Memorandum

**Subject: Discussion of Corrosion Monitoring Methodologies
At Oyster Creek Nuclear Plant Dry Well**

Figure 1

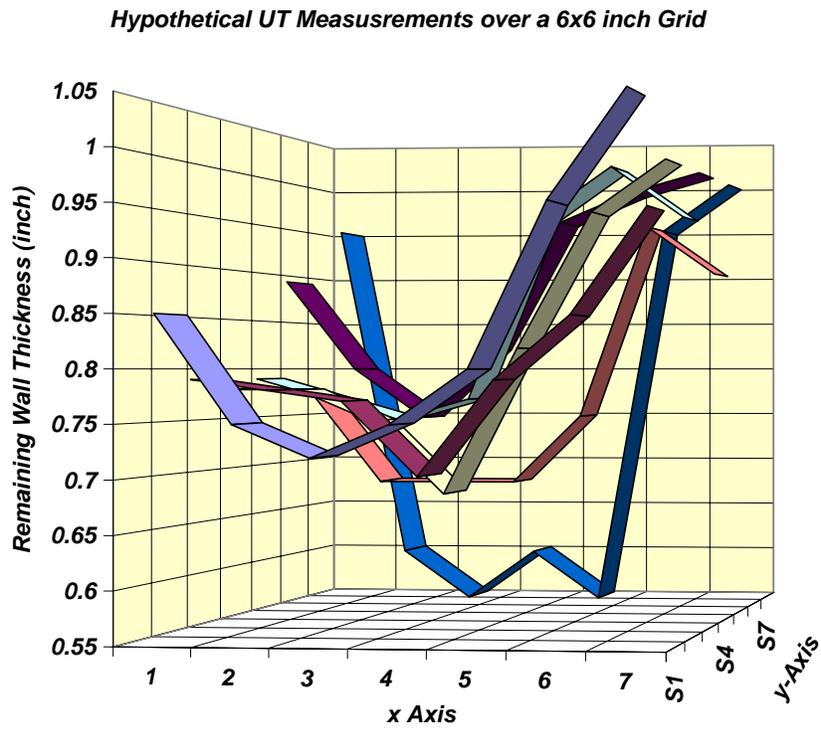
Since the actual original UT measurements were not available for a detailed statistical analysis, a hypothetical 6x6 inch grid was constructed to illustrate a point to be made here. **Figure 1** shows hypothetical UT measurements in a 6x6 grid with 1 inch spacings. The average wall thickness over the grid is 0.81 inches. However, as is often the case in real life, a corrosion trough is depicted parallel to the y-axis with an average depth of 0.68 inches and a maximum depth of 0.55 to 0.60 inches. While this example is not a real life observation, it nevertheless illustrates how averages can be misleading. In this particular case, the corrosion trough exceeds the grid, and one could not tell whether corrosion would become more severe or less severe beyond the boundaries of the grid. Similarly, when Amergen talks about "isolated minimum thickness measurements", one does not know where these were recorded and whether there were others, which exceeded the average wall loss, but

Figure 2

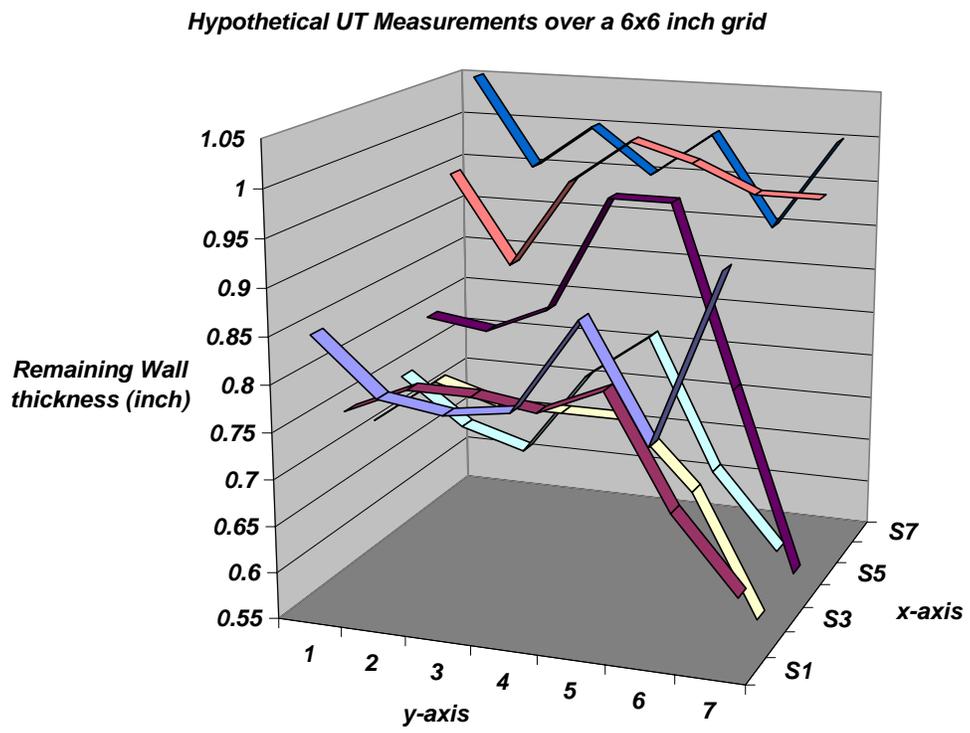
may have been above the quoted minimum wall thickness. When the same data shown in Figure 1 are plotted from a different perspective (Figure 2), conclusions may be different, but again it appears that there may be an extensive corrosion phenomenon on one side of the grid.

Figure 3

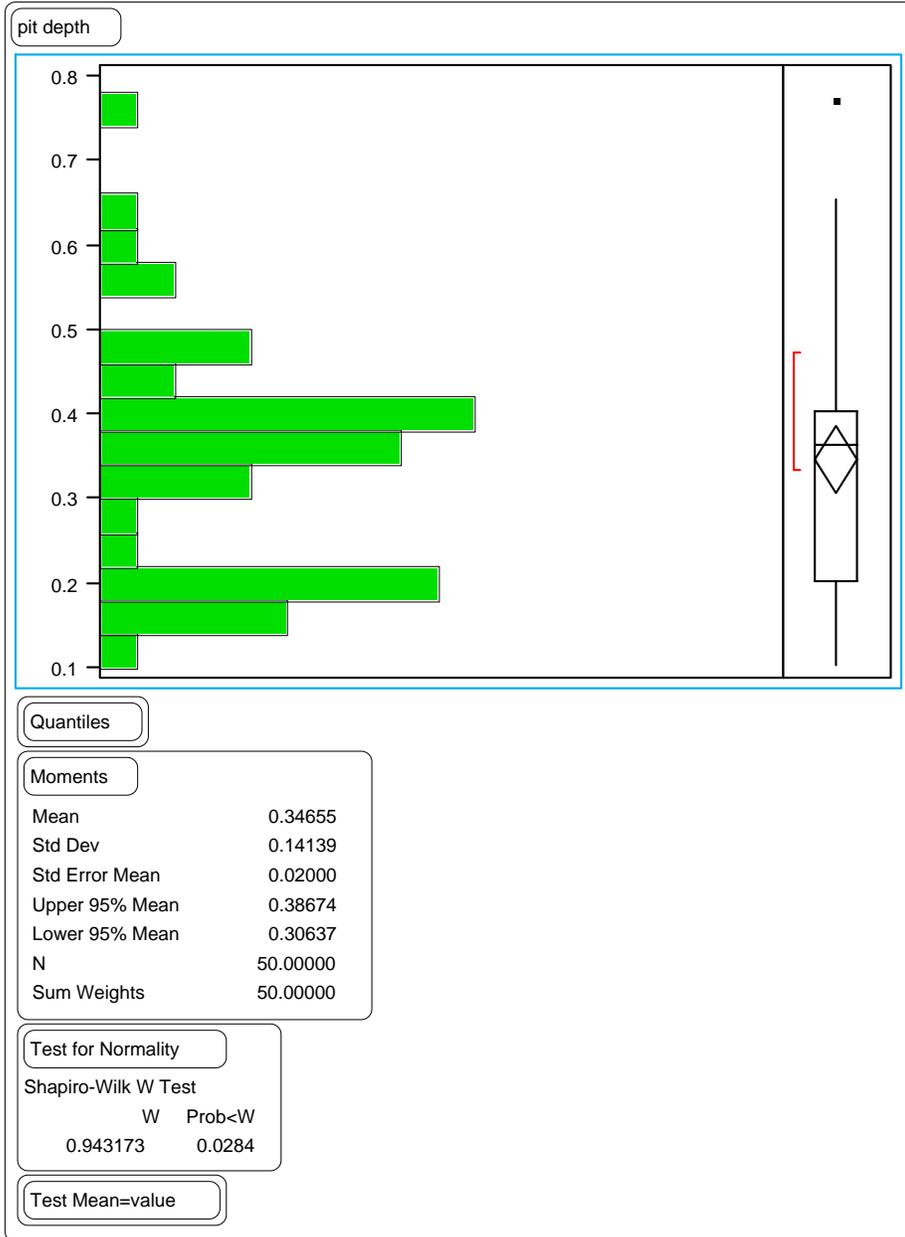
It is generally accepted that failures do not occur as a result of average corrosion, but are generally occasioned by the weakest spot in the system. As a consequence, one cannot interpret the data by calculating averages and standard deviations. Figure 3 for instance shows a histogram of the 49 hypothetical UT measurements. It can clearly be seen that in this example a bimodal distribution exists. The first mode, covering small pit depths, is perhaps Gaussian, as is often observed for pit initiation, because the smallest pits, too difficult to count, are rarely included in the analysis. The second mode is represented by a skewed distribution, perhaps a Weibull distribution with very high extreme values. Again this type of distribution is often observed after pitting has progressed for some time. It would clearly be irrational to try and present data of this kind by a Gaussian distribution and disregard the values that are outside “confidence limits”. Rather, data of this kind should be analyzed by Extreme Value statistic. It turned out, as shown in Figure 4 that a reasonably straight line is obtained when the pit depths are plotted as a function of the “reduced variate”. Only 49 points were available for the correlation. Extrapolation to the virtual 100th point results in a pit depth of about 0.77 inch, a remaining wall thickness of about 0.4 inches, or in this hypothetical case, a remaining wall thickness of less than minimum allowable. Because a worst case analysis is necessary for a safety-critical condition, the data must be analyzed by a methodology similar to the one demonstrated in the above procedure. Unfortunately, at present AmerGen appears to take no account of the chance that the true value of the remaining wall thickness at each point could actually be substantially less than indicated. See Ex. NC 3 at Sheet 6.

b. Figure 5

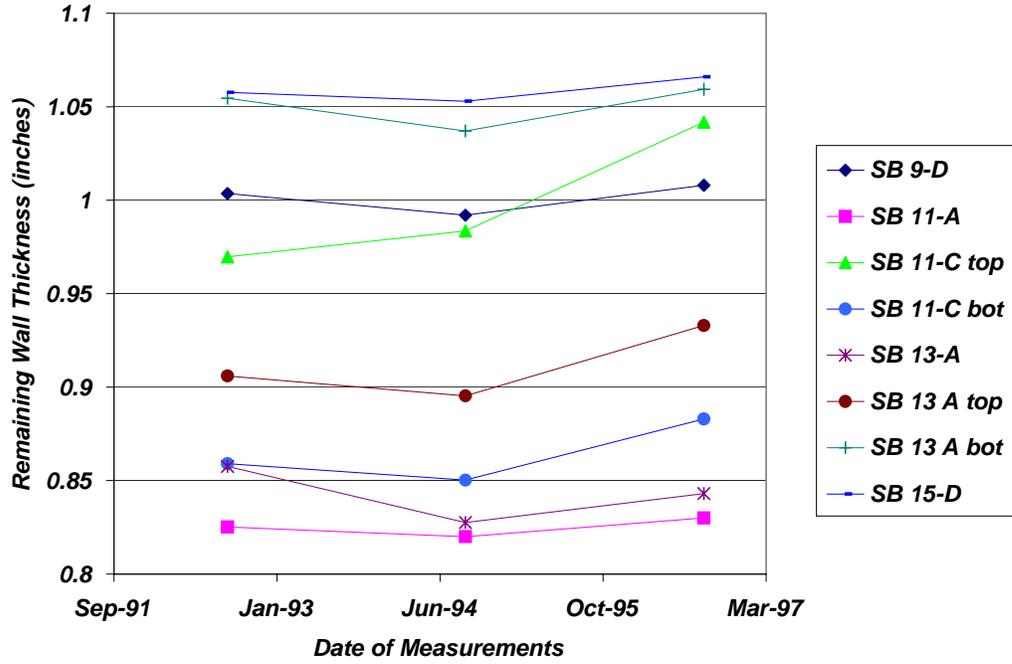
Turning to the corrosion rate, AmerGen attempted to predict corrosion rates based on the '92, '94, and '96 UT measurements. They used the averages for each grid measured in each by over the time period indicated. (This procedure is based on the notion that all pits grow at the same rate, which is quite erroneous since the deepest pits usually grow faster than the smaller ones.) In most instances it turned out that the 92 averages were higher than the 94 averages, while the 96 averages were again

higher than the previous two. This is shown in [Figure 5](#). However, a statistical Analysis of Variance (ANOVA), [Figure 6](#), shows that there is no significance to these variations from date to date if the data are amalgamated. However, the differences from location to location are indeed very significant. On the basis of these data Amergen concluded that the corrosion was arrested following the application of the epoxy coating. It is probably correct that *on average* the corrosion was significantly slowed or even arrested during the four years covered by the measurements. Whether the extreme corrosion rates were also similarly affected remains an open question. Nevertheless, it would be logical to expect that corrosion slowed down following the application of the coating, at least for a period of time. It is, however, stretching credulity to assume that such protection would last in excess of the stated lifetime of the coating, which was specified as 8 to 10 years.

Figure 7

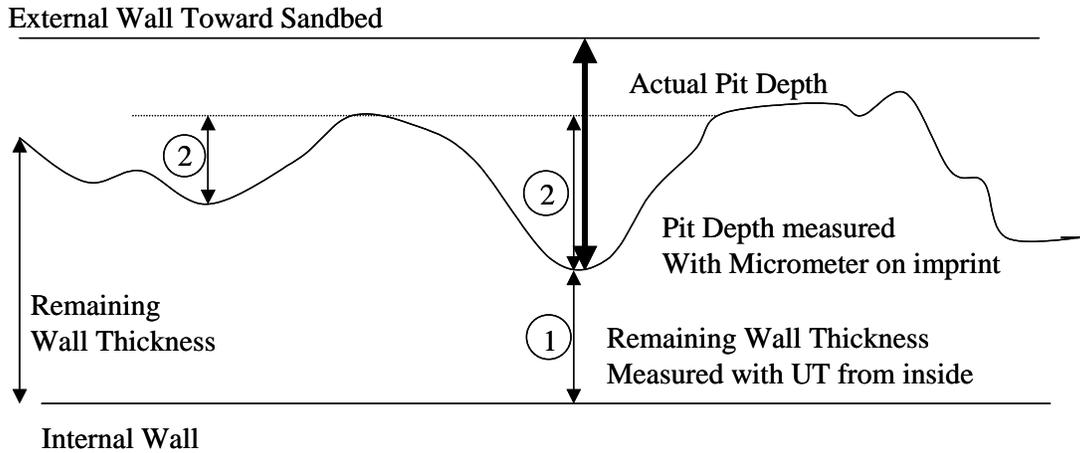
Figure 7 is a schematic of what I understand was done to arrive at a representative remaining wall thickness in the former sandbed region in order to subsequently perform GE type vessel integrity calculations. First: UT measurements were taken from the inside as described earlier. Second: an imprint (or cast) was taken from the

outside in order to characterize the roughness of the corroded surface in addition to the UT measurements. The roughness is also characterized as “dimples”. The depth of the dimples was measured from the imprint by means of a micrometer. Thus, **Figure 7** shows the UT measurement (1) from the inside, which characterizes the remaining wall thickness. Second, the dimple depths were measured (repeatedly) and averaged (2). This average was added to each UT measurement. Third, a characteristic average dimple depth was determined and used as a global average to be used in all areas where imprints were not available, or where such were performed in a reduced fashion. The reason for this procedure is not entirely clear, other than hopefully arriving at a representative average, which could be the basis for the integrity calculations.

As can be seen from Figure 7, the first location: if the average dimple depth is added to the UT remaining wall thickness, and then a global average dimple depth is being subtracted from the result, the actual pit depth may be reduced. In the second location the actual average pit depth may be increased by this procedure.

Figure 8

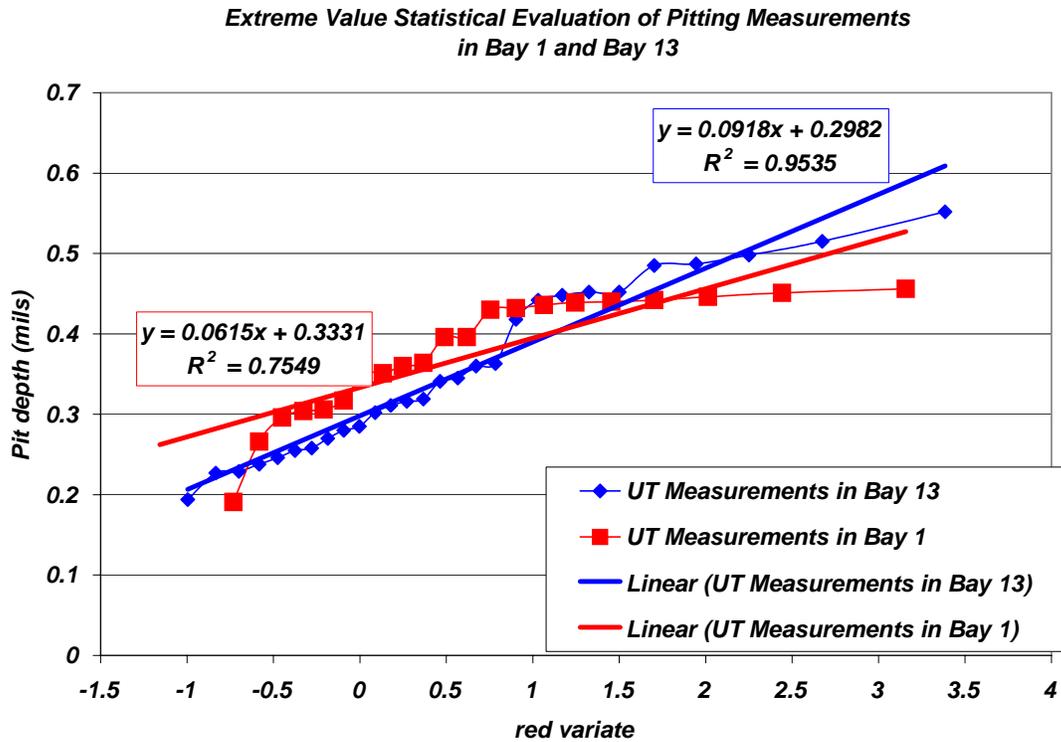
Figure 8 shows the extreme value statistical evaluation of the UT Measurements in Bays 1 and 13. It can be seen that worst case penetrations can be predicted to be of the order of 550 to 600 mils, or dangerously close to the criteria for the remaining local wall thickness of 490 mils. Hence, predictions of this nature, which in the case of Bay 13 are reasonably accurate, ($R^2 = 0.95$), are considerably less optimistic than those of GPU Nuclear.
